**PLEASANT PRAIRIE PLAN COMMISSION MEETING
VILLAGE HALL AUDITORIUM
9915 39th AVENUE
PLEASANT PRAIRIE, WISCONSIN
6:00 P.M.
MARCH 23, 2015**

- A. **PUBLIC HEARING AND CONSIDERATION OF PLAN COMMISSION RESOLUTION #15-06 FOR THE FOLLOWING COMPREHENSIVE PLAN AMENDMENTS** for the request of Leah Berlin on behalf of Kwik Trip, Inc. related to the proposed development of a Kwik Trip to be located at the southwest corner of STH 50 and CTH H: 1) to amend the Village 2035 Land Use Plan Map 9.9 to remove the urban reserve land use designation from the property identified as Tax Parcel Number 91-4-122-081-0010 to ensure that both the Zoning Map and the Comprehensive Land Use Plan are consistent; and 2) to update Appendix 10-3 of the Village of Pleasant Prairie Wisconsin, 2035 Comprehensive Plan to reflect the above noted changes to the 2035 Land Use Plan Map 9.9.

- D. **PUBLIC HEARING AND CONSIDERATION OF A CONDITIONAL USE PERMIT INCLUDING SITE AND OPERATION PLANS AND DIGITAL SECURITY IMAGING SYSTEM AGREEMENT AND ACCESS EASEMENT** for the request of Leah Berlin on behalf of Kwik Trip, Inc. related to the proposed development of a Kwik Trip to be located at the southwest corner of STH 50 and CT

DRAWN BY JSK/RWI
SCALE 1" = 30'
JSD PROJ. NO. 14-6612A
DATE 02-15-2015
SHEET 5 OF 22 SP3.1

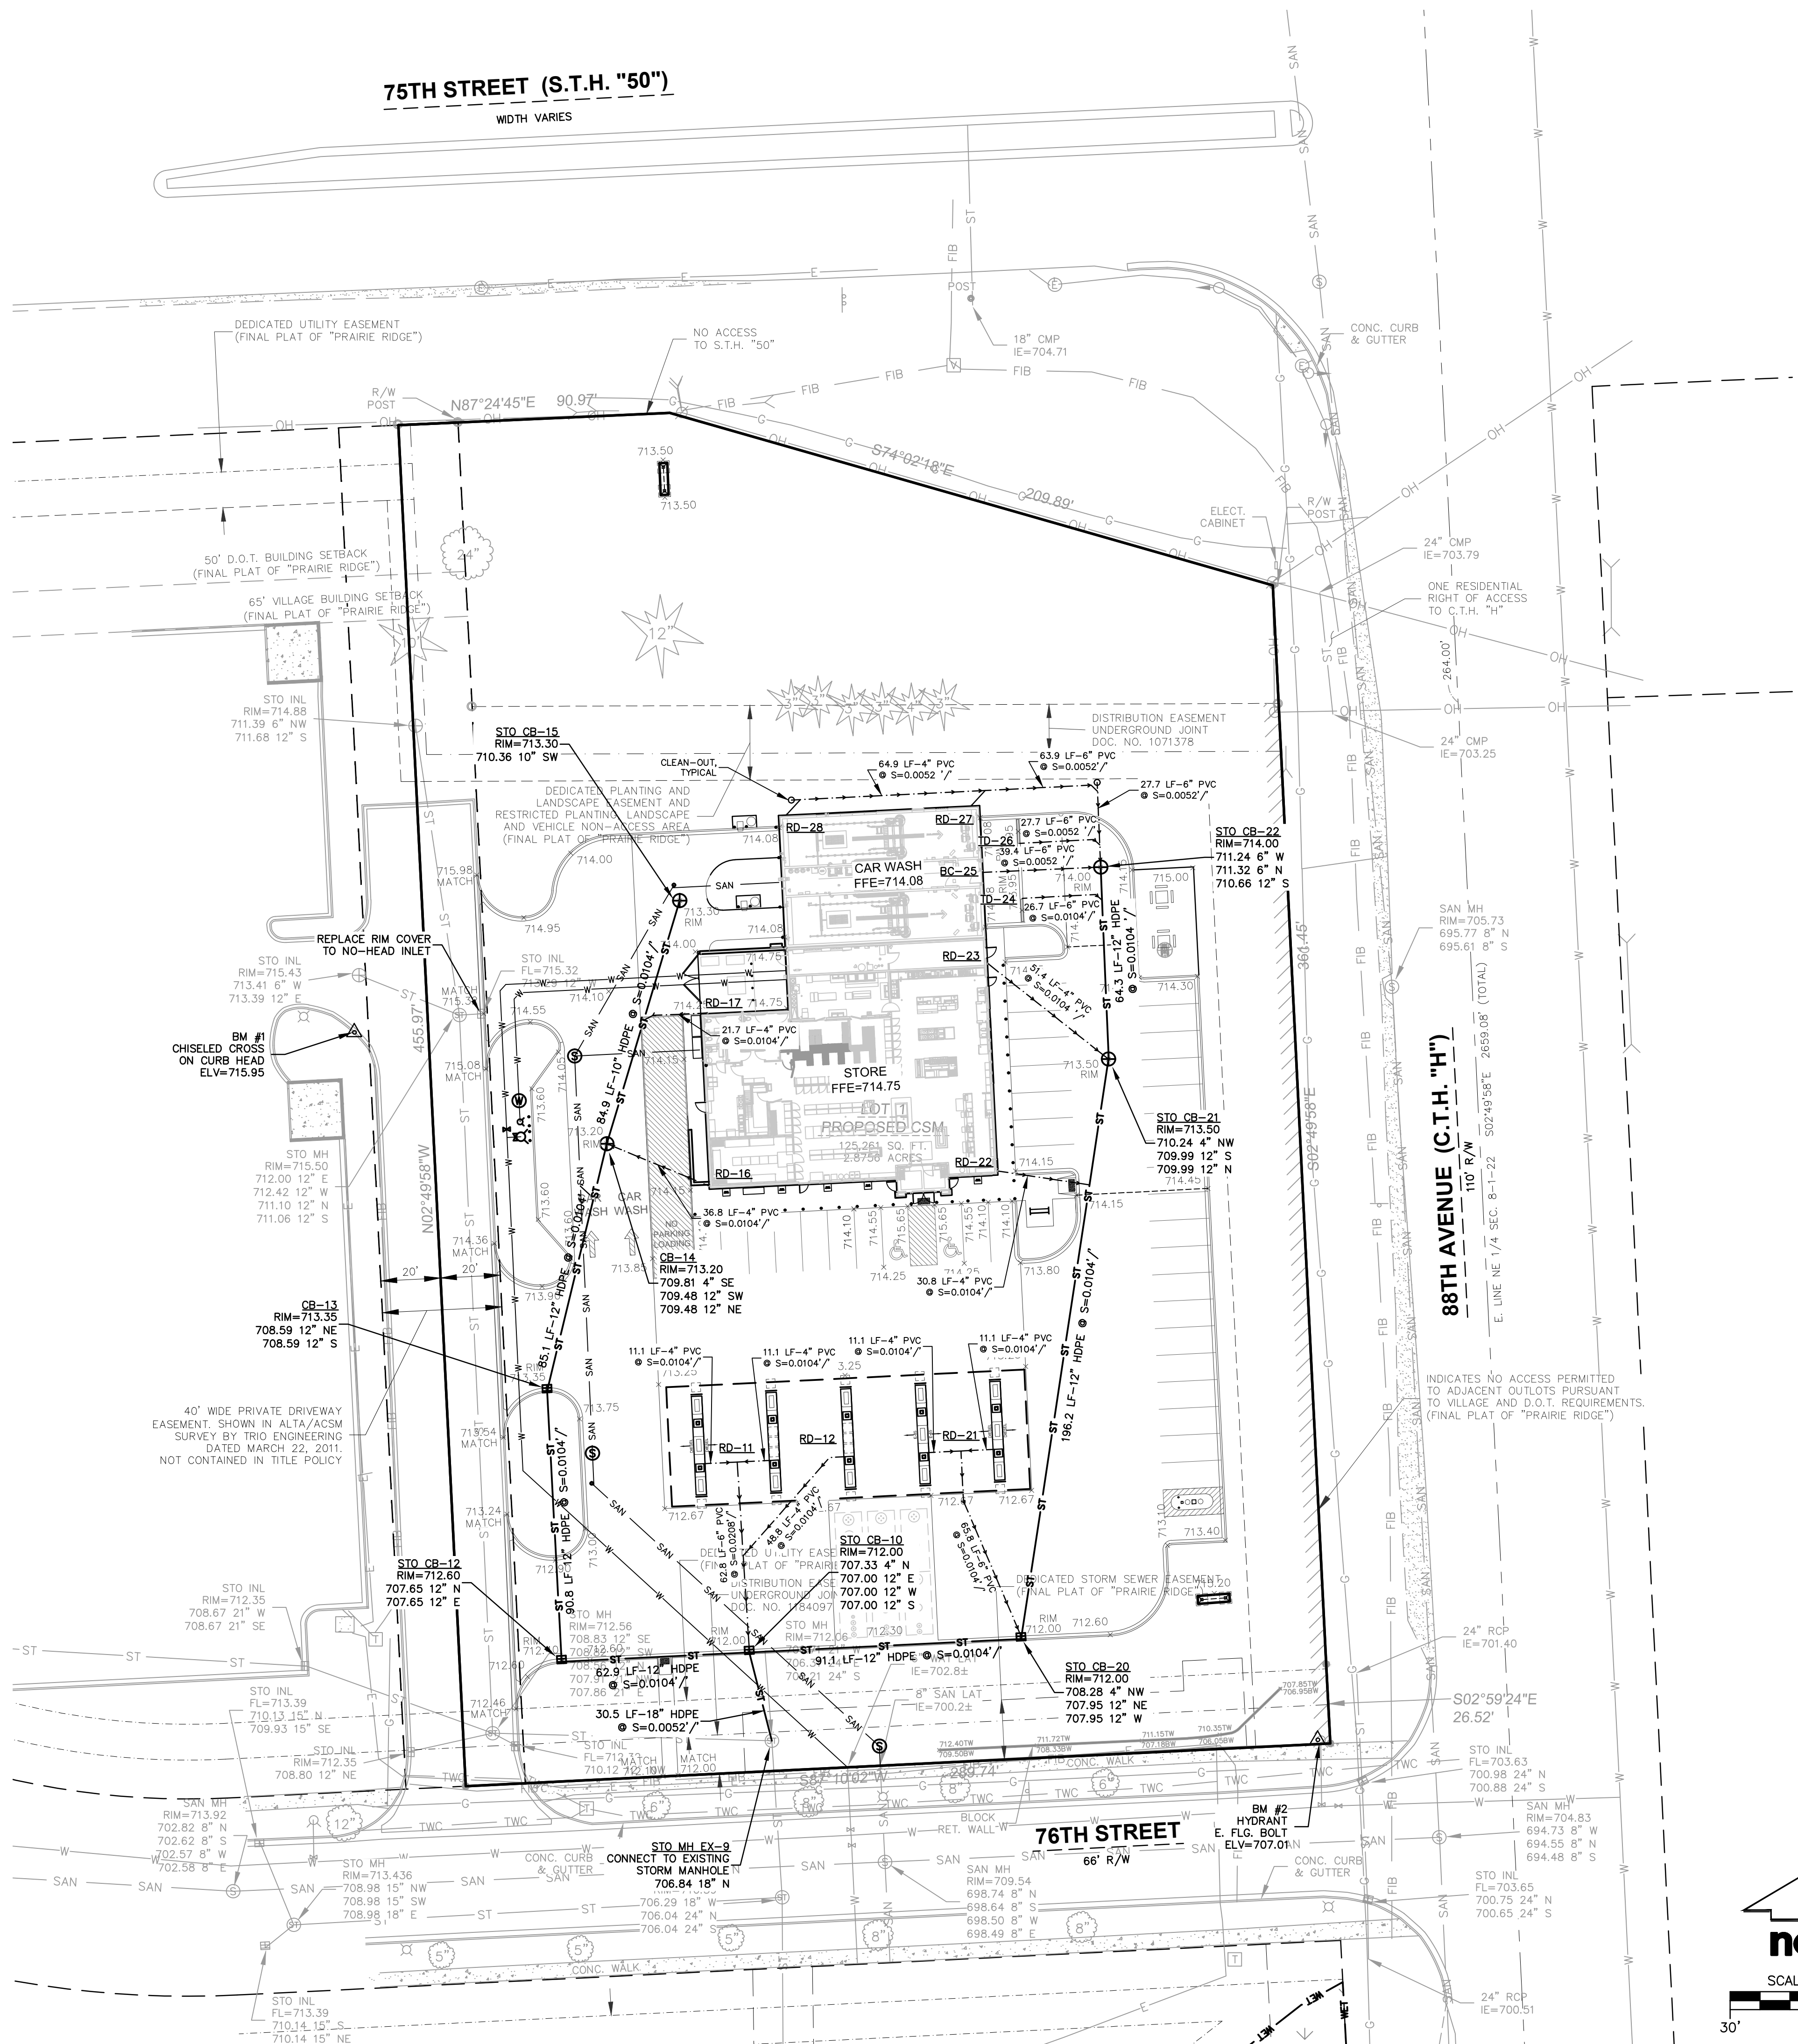
- vii. On the *Utility Plan – Storm Sewer (Sheet SP4.0)* the following shall be changed:
- (a.) Provide the model of catch basin casting to be installed on the existing catch basin located within the north entrance.

- (b.) Change the contact information for Utility Note #15 to the Village Public Works Department, 262-925-6700.
- viii. On the *Utility Plan – Sanitary Sewer and Water Services (Sheet SP4.1)* the following shall be changed:

DRAWN BY JSK/RWI
 SCALE 1" = 30'
 JSD PROJ. NO. 14-6612A
 DATE 02-15-2015
 SHEET 6 OF 22 SP4.0

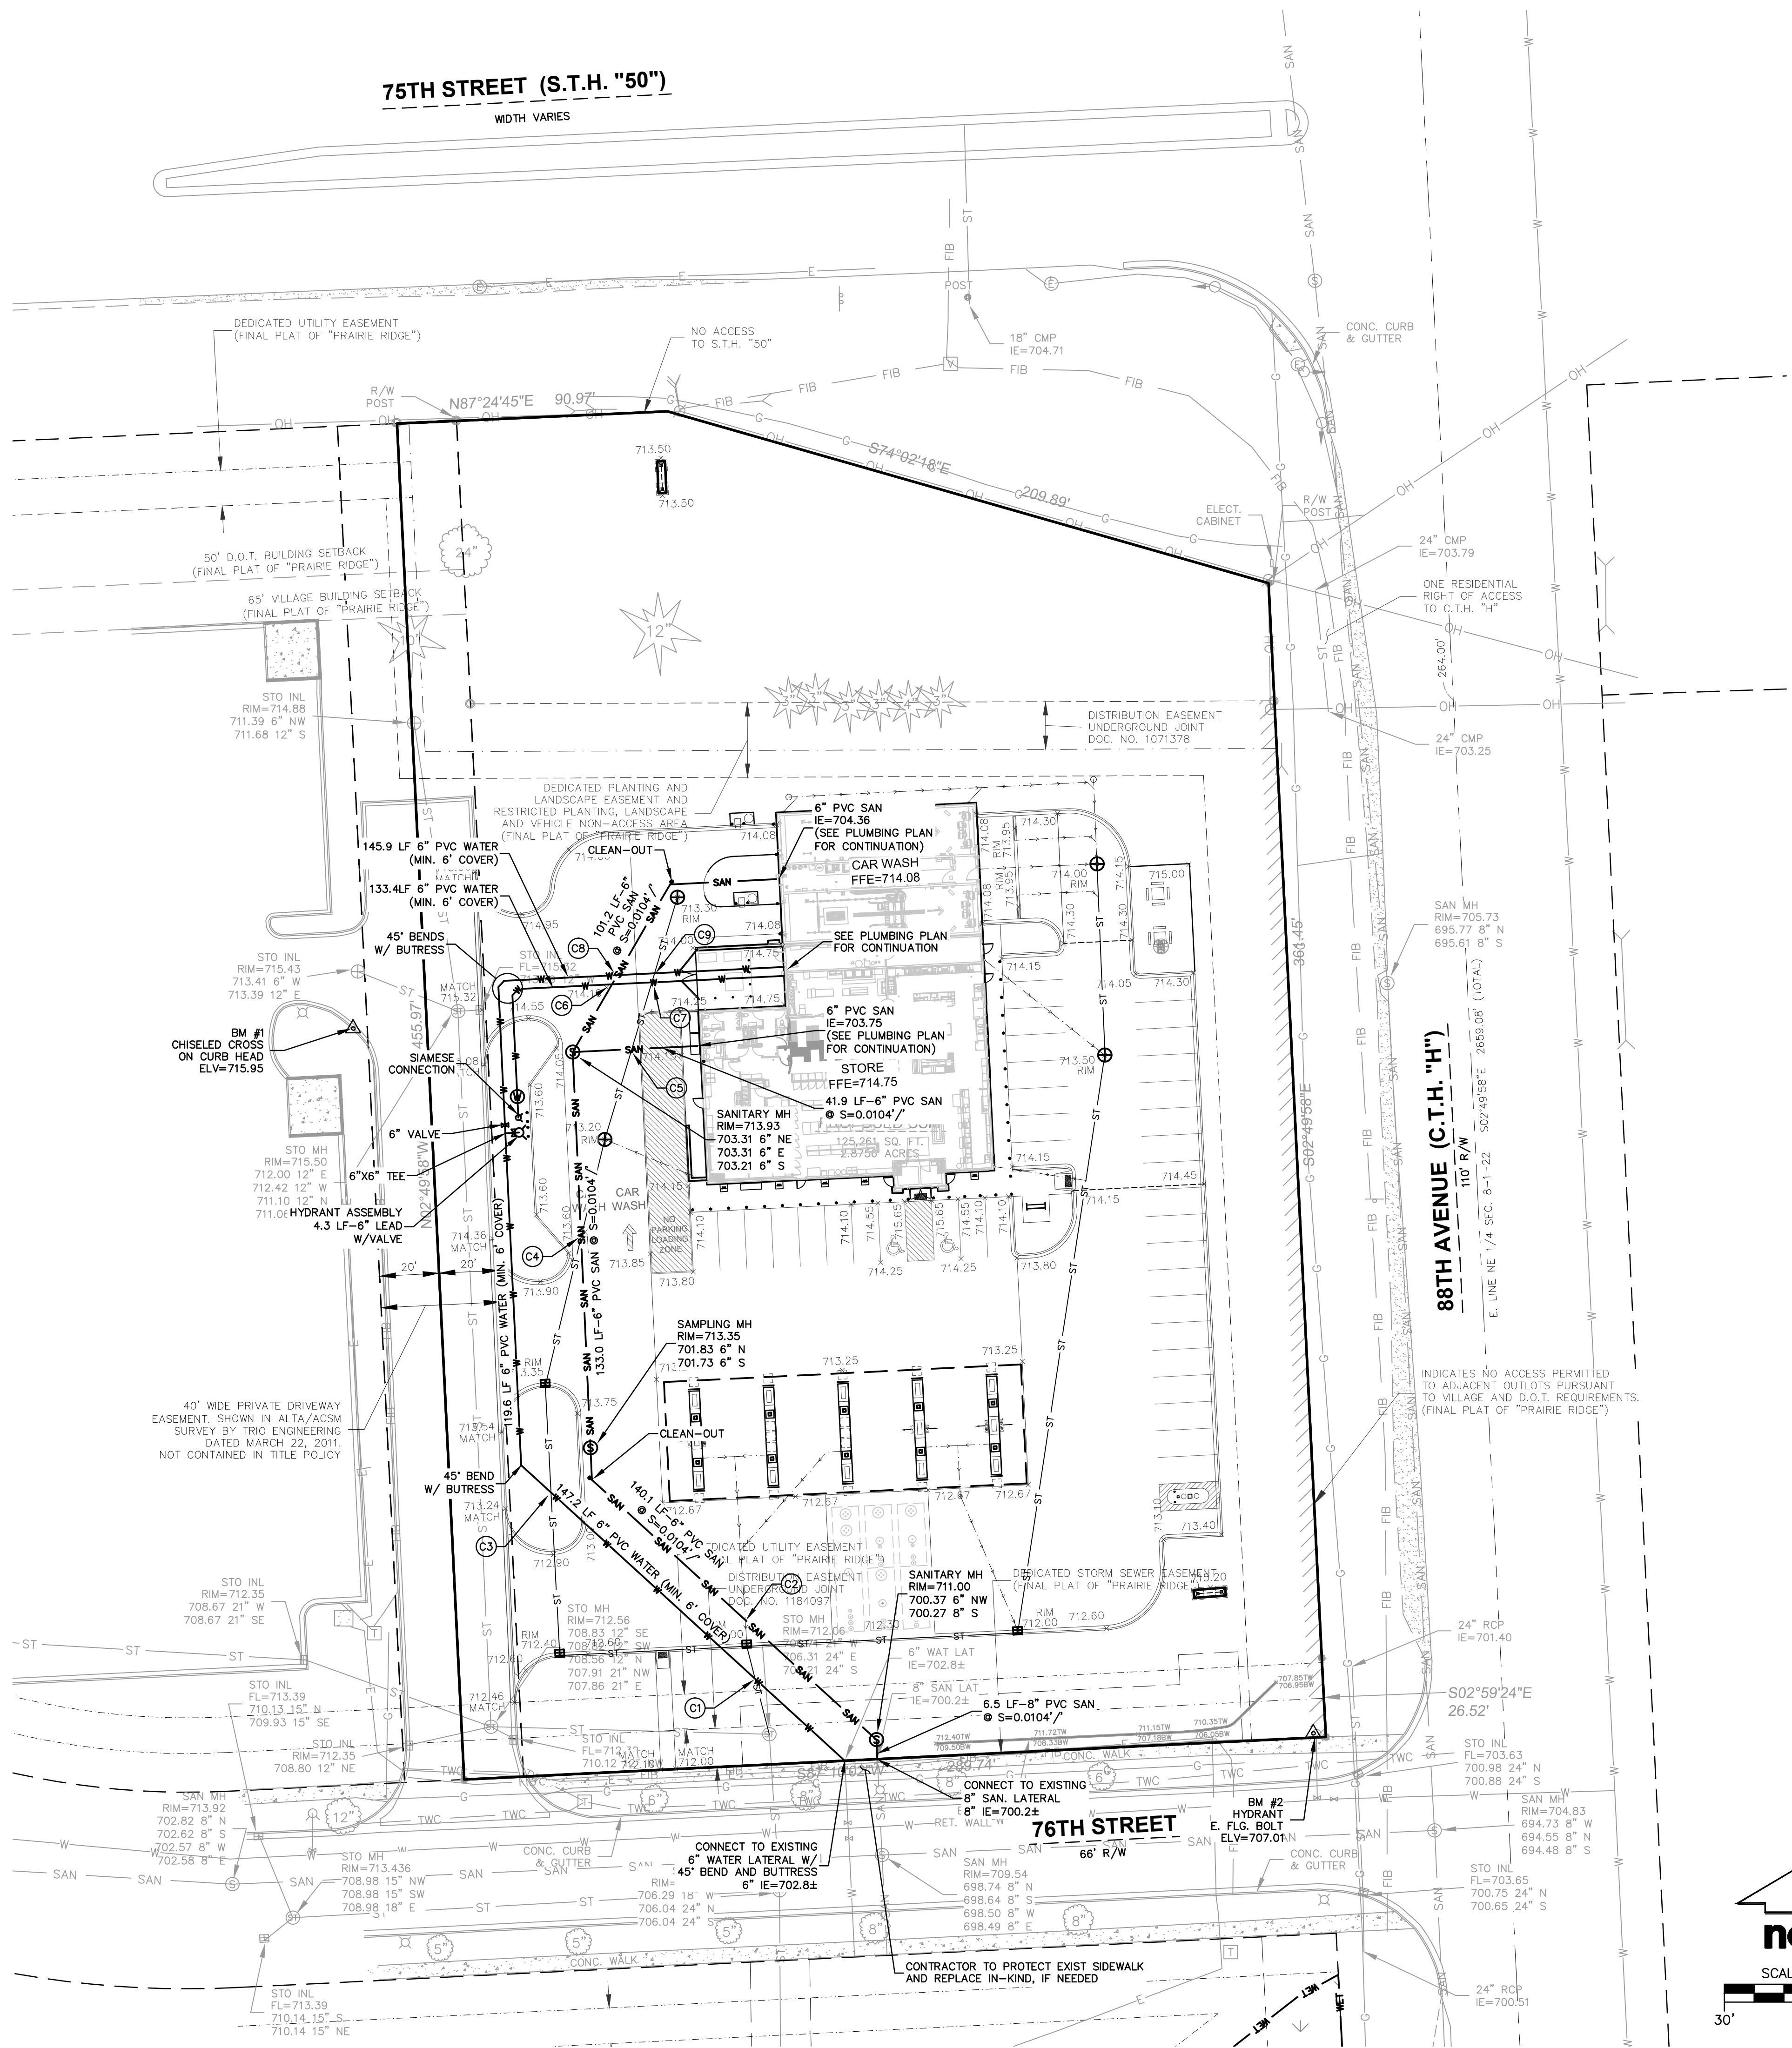
- ii. Utility Note 15 - contact John Steinbrink, Jr. with the Public Works Department, phone number: 262-925-6768.
- n. Modify Plan Sheet 8, show the location of any construction trailer, shown cyclone construction fencing detail for around the perimeter of the property. Note the orange construction fencing around the canopy of all trees (including street trees) being protected during construction.
